Construction Change Directive

PROJECT: *(name and address)*
Highland Township Fire Station 2
PIA #18-122B

CCD INFORMATION:
Directive Number: 001
Date: July 13, 2021

“EXHIBIT A” – CCD NO. 1

C-6 SITE SEPTIC SYSTEM DETAILS

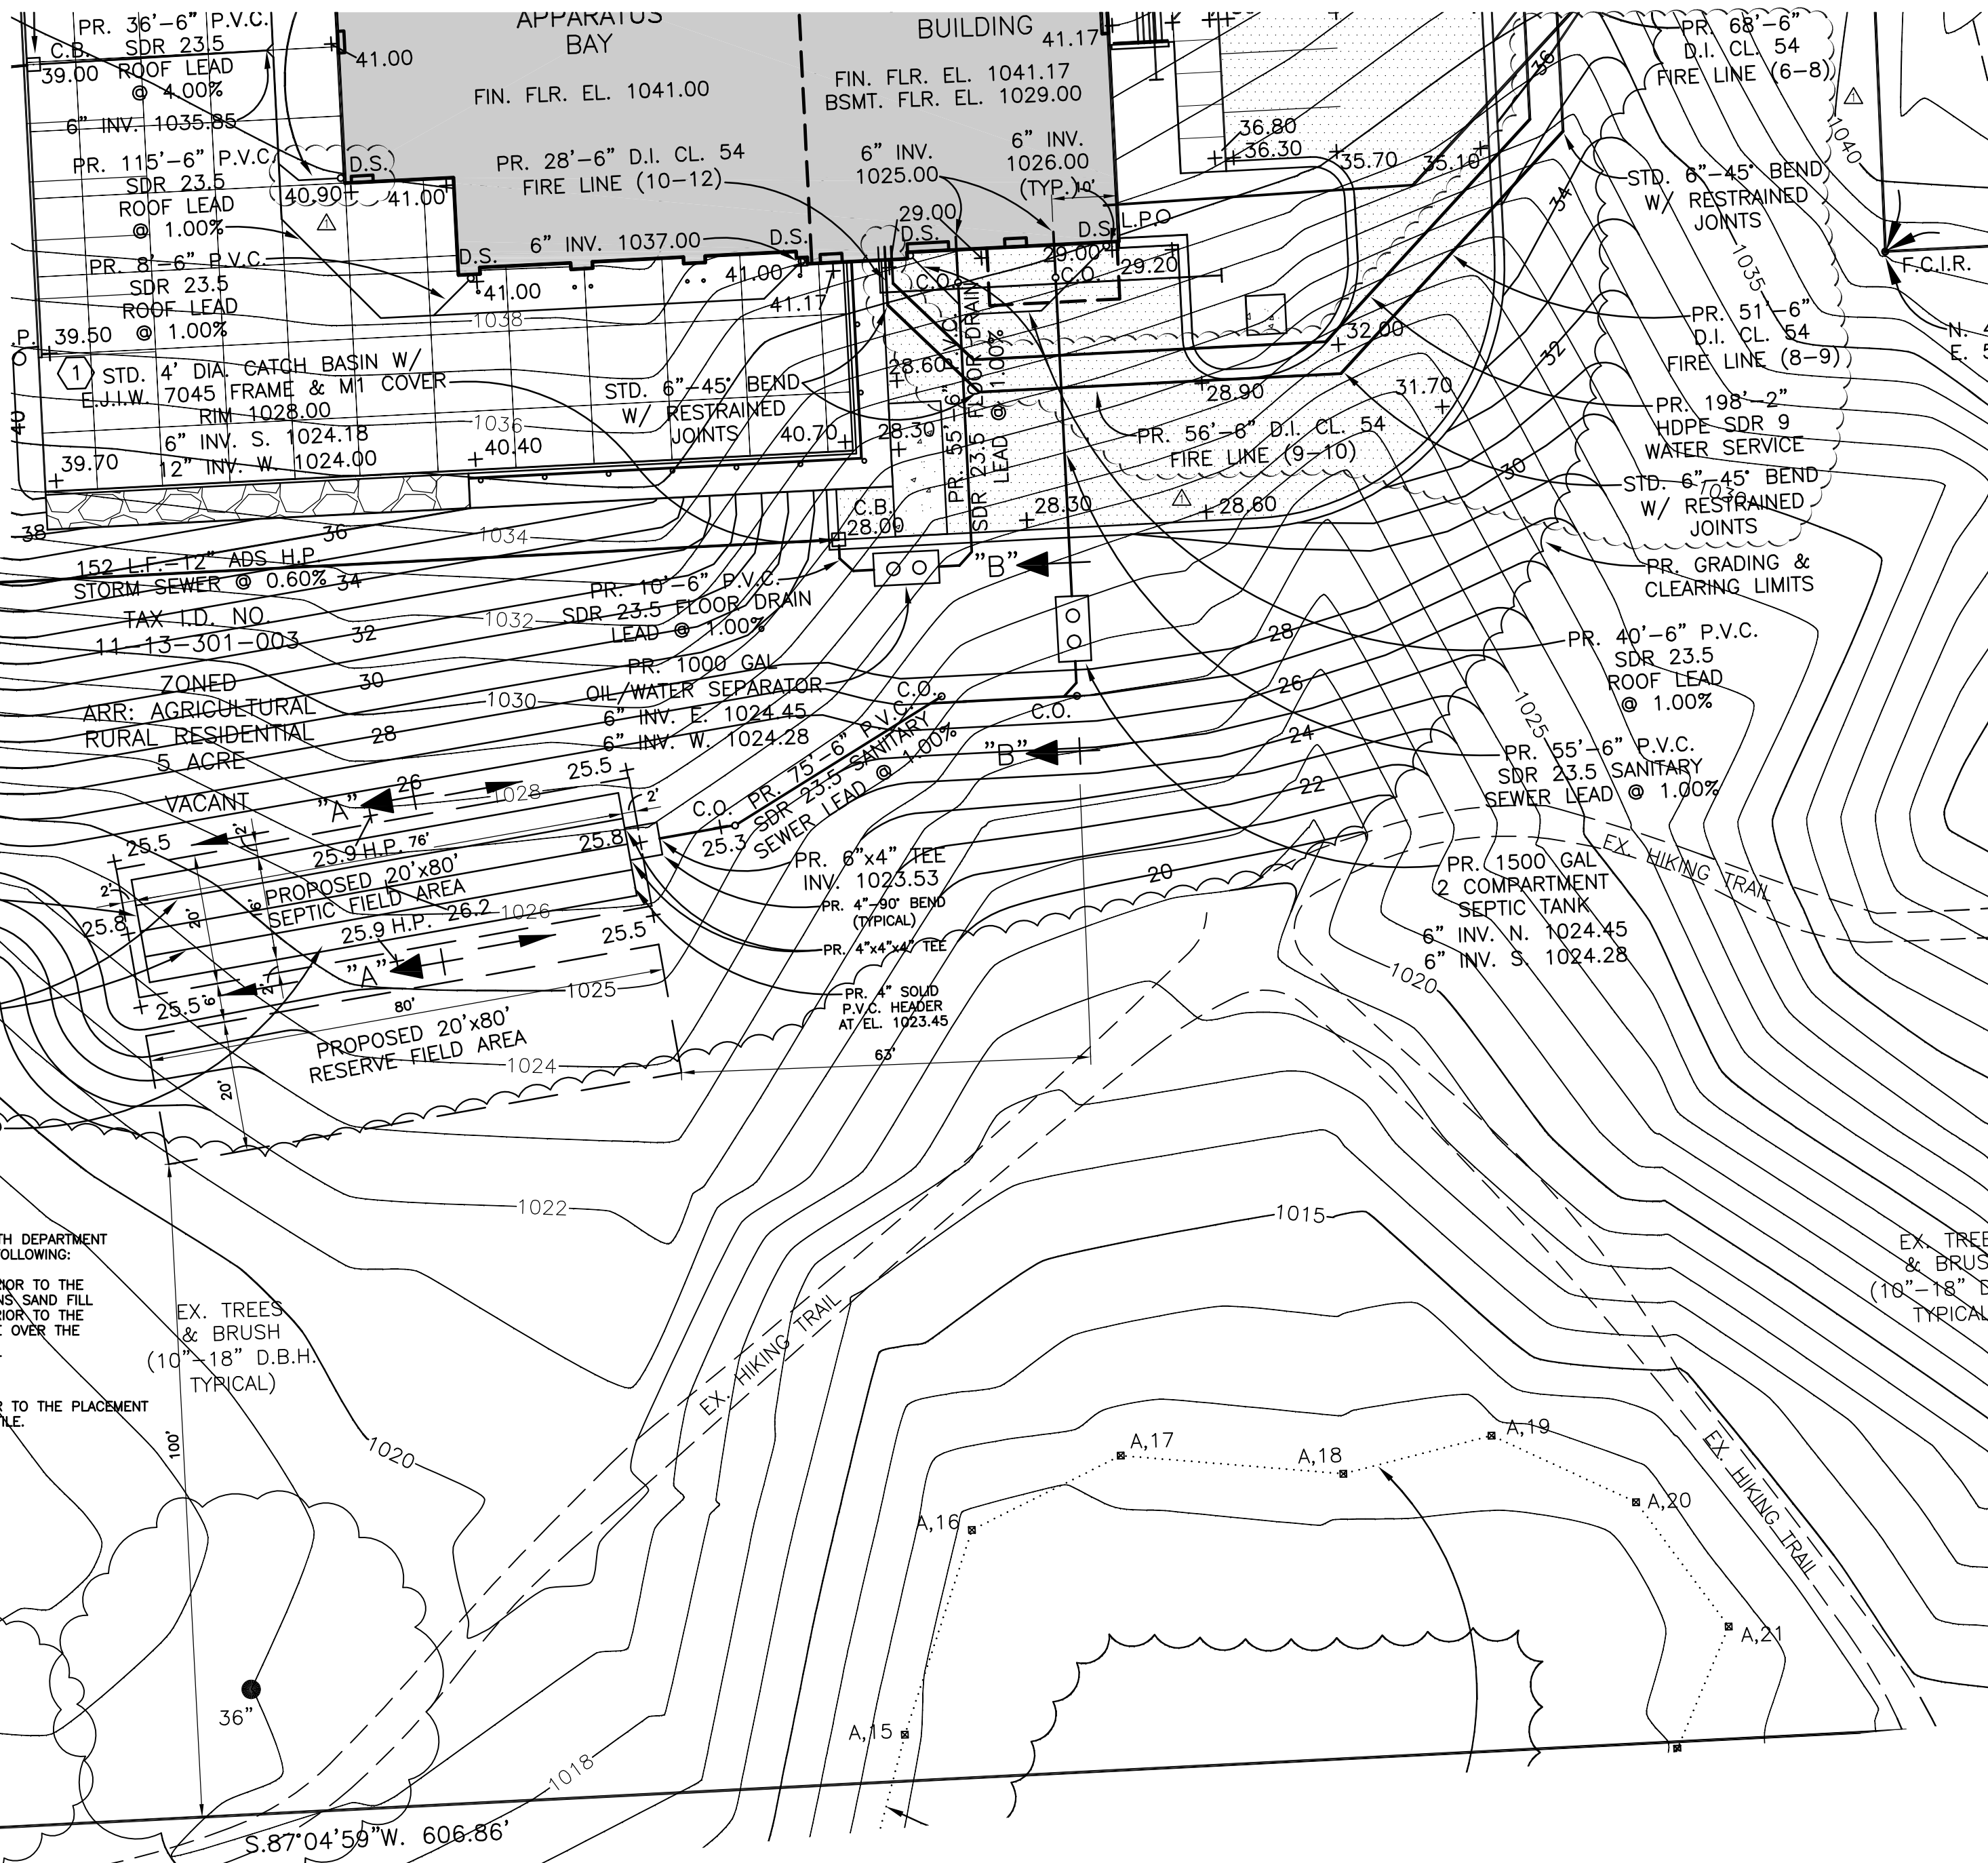
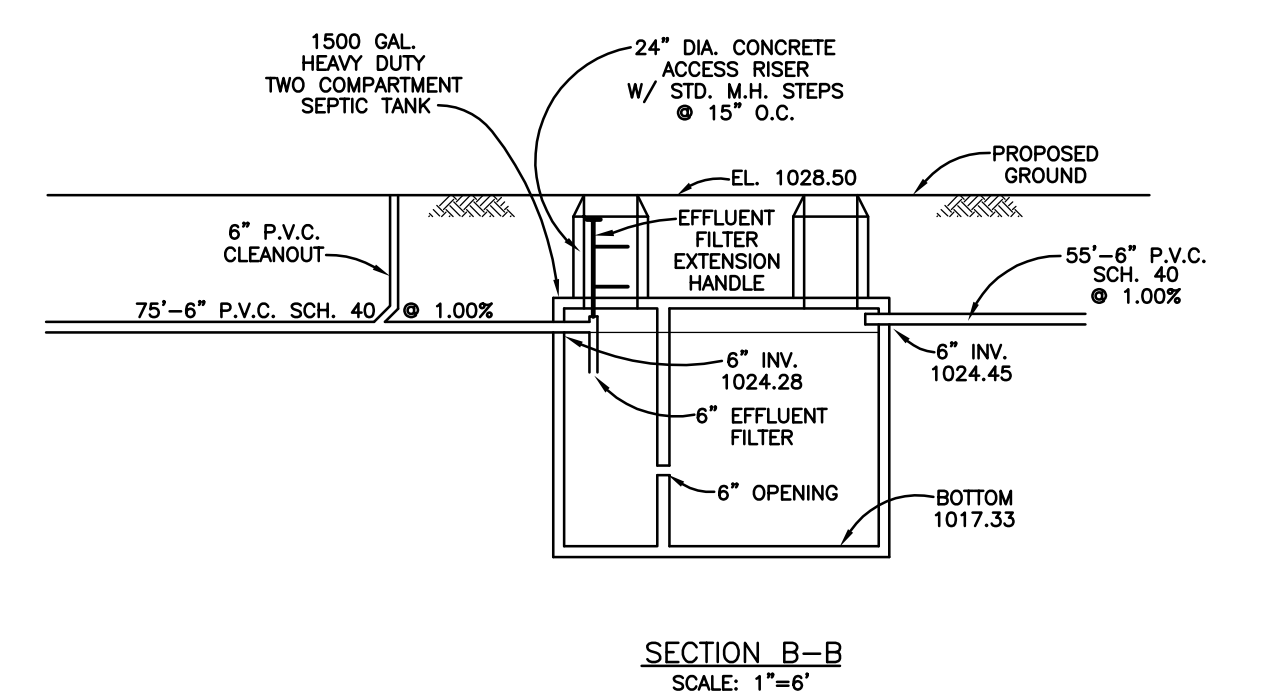
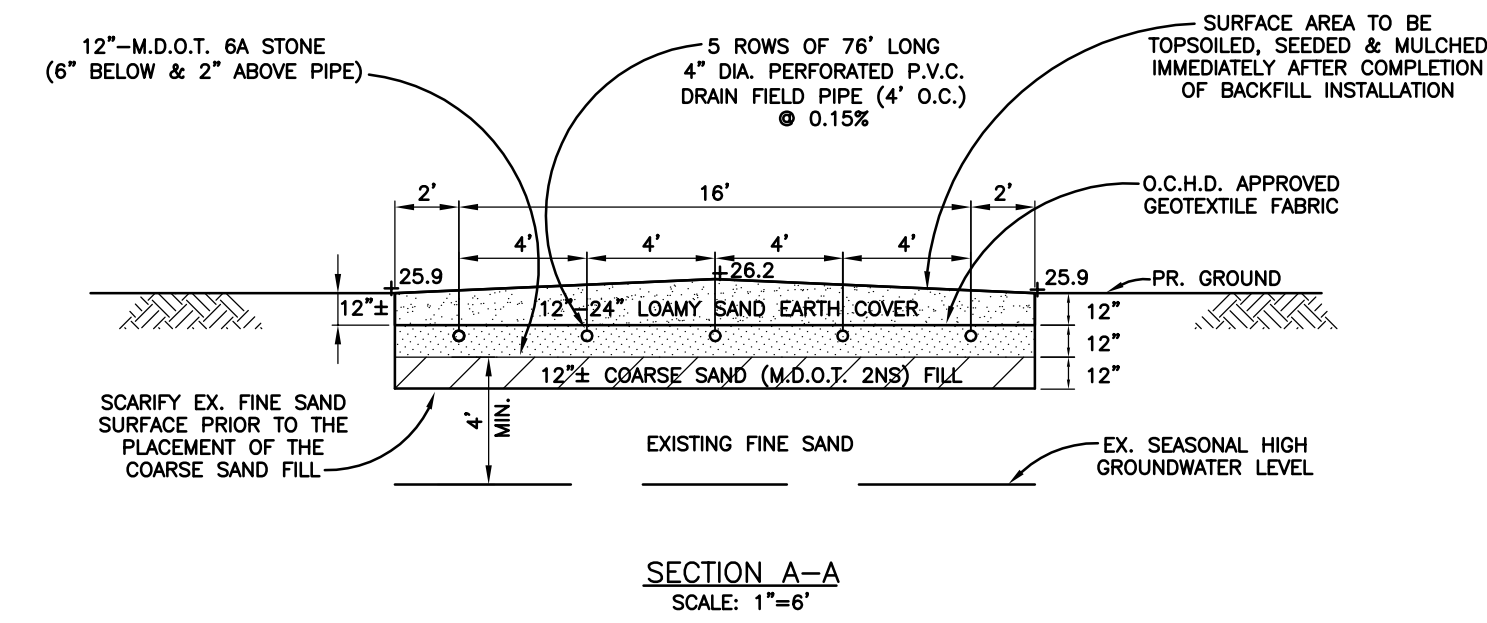
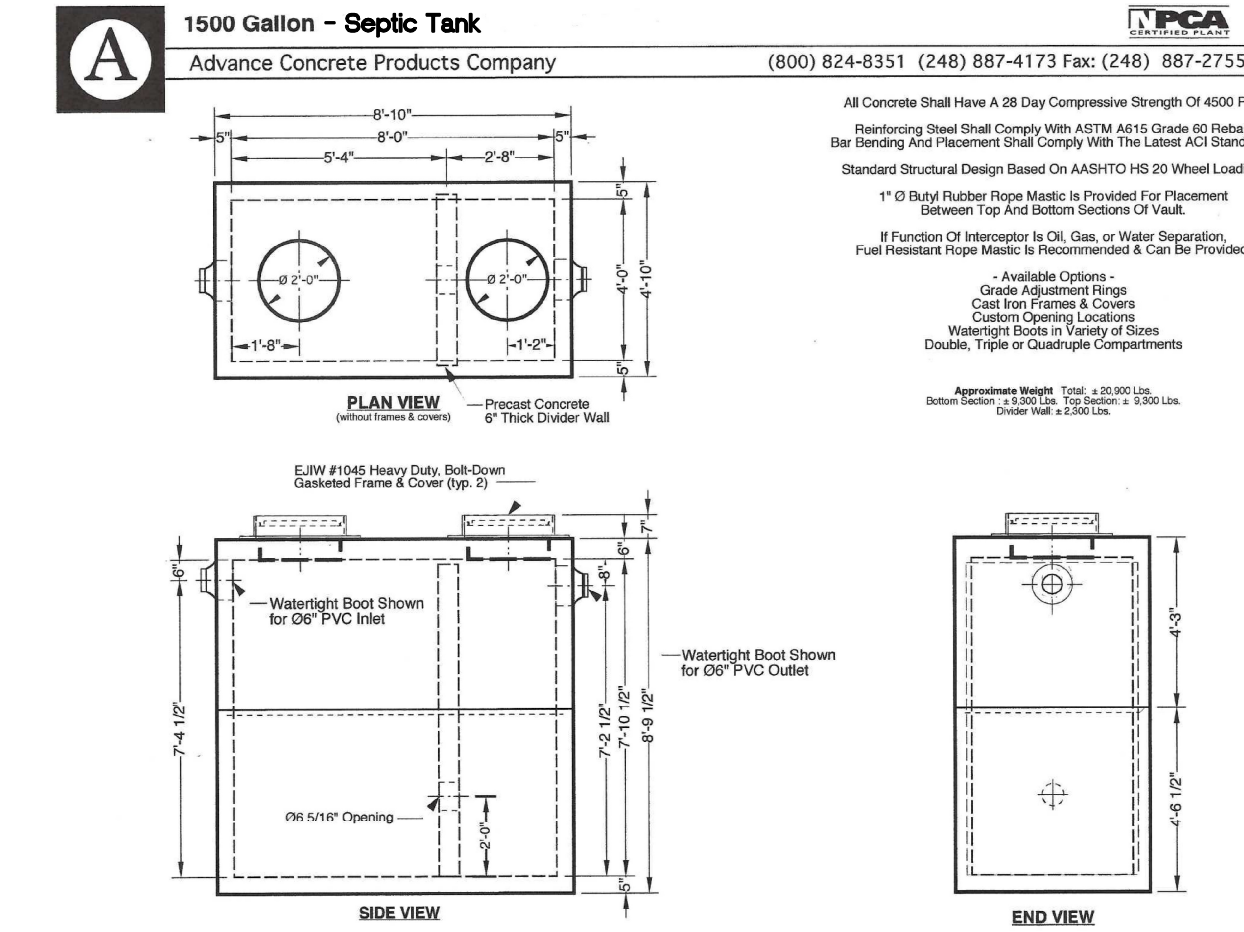
- A. Replaced single center downspout pipe on building west end with ones at northwest & southwest building corners.
- B. Replaced single 8" water lead south of hydrant lead tee with separate 2" water service and 6" fire line

A3-03 DIMENSION PLAN

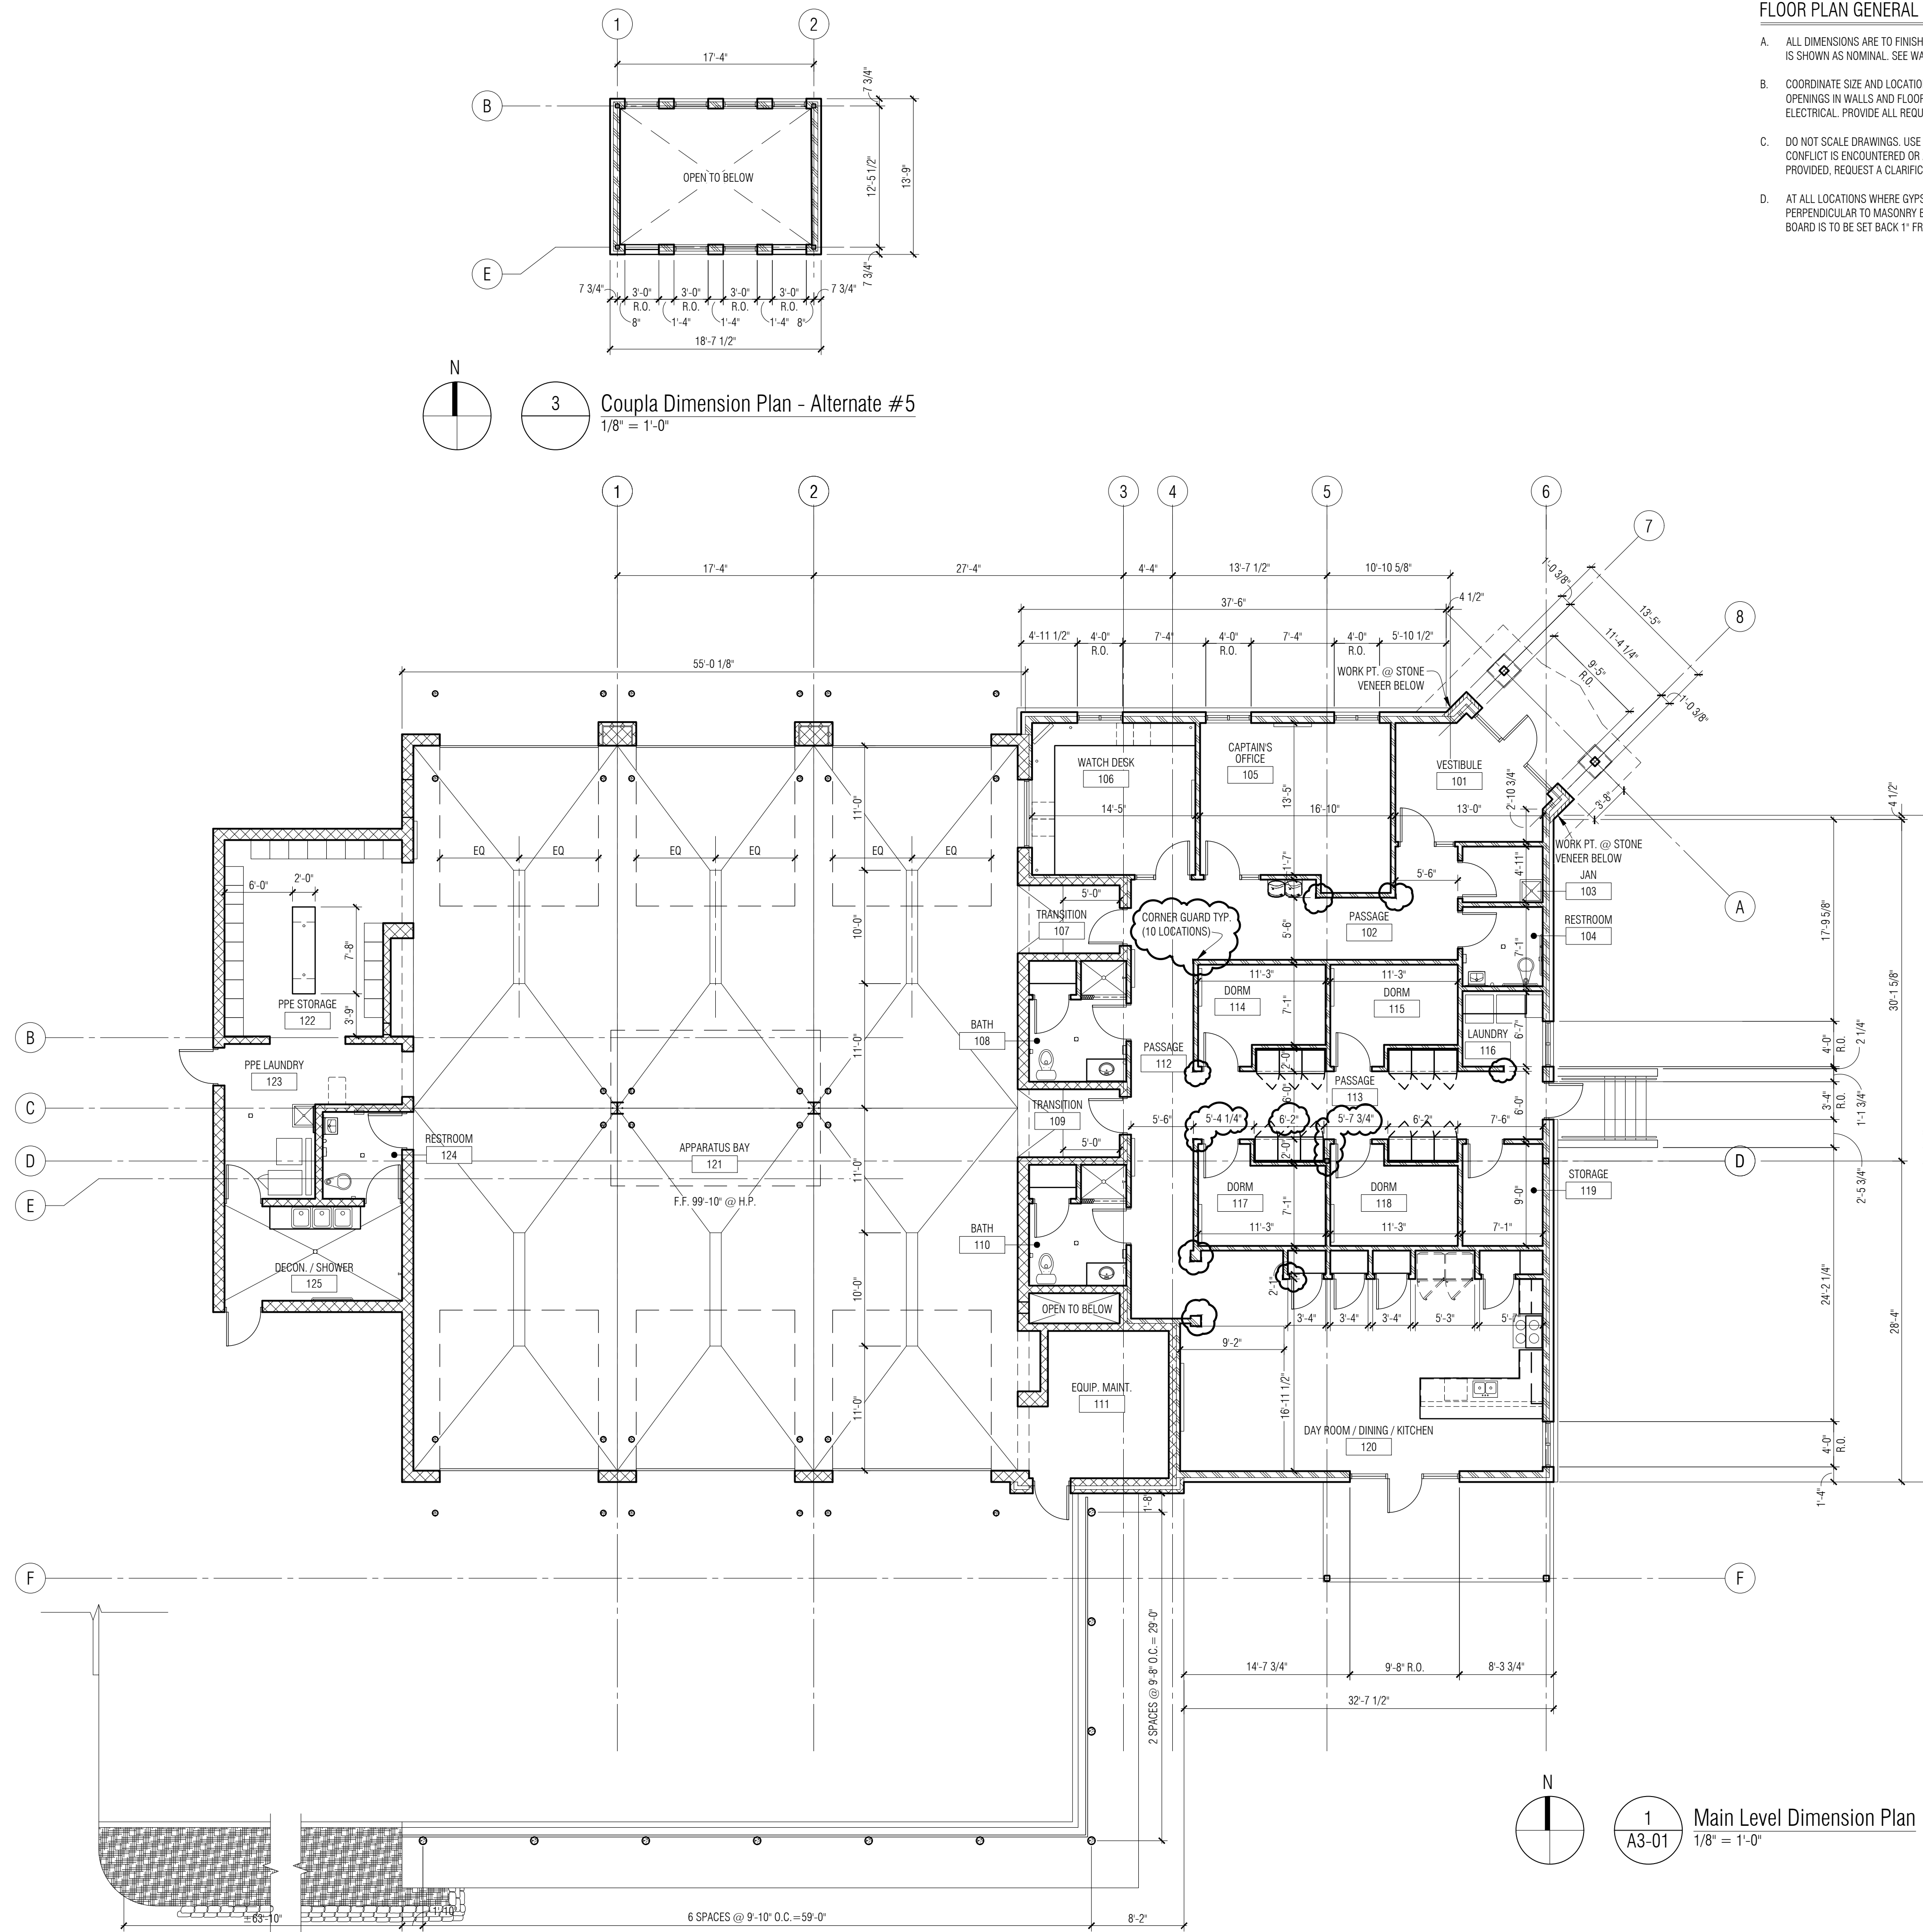
- A. Add (10) ten corner guards.
- B. Add steel column D5 and increase width of partition to 7 1/4" as noted on plan.
- C. Revise dimensions in Passage 113.
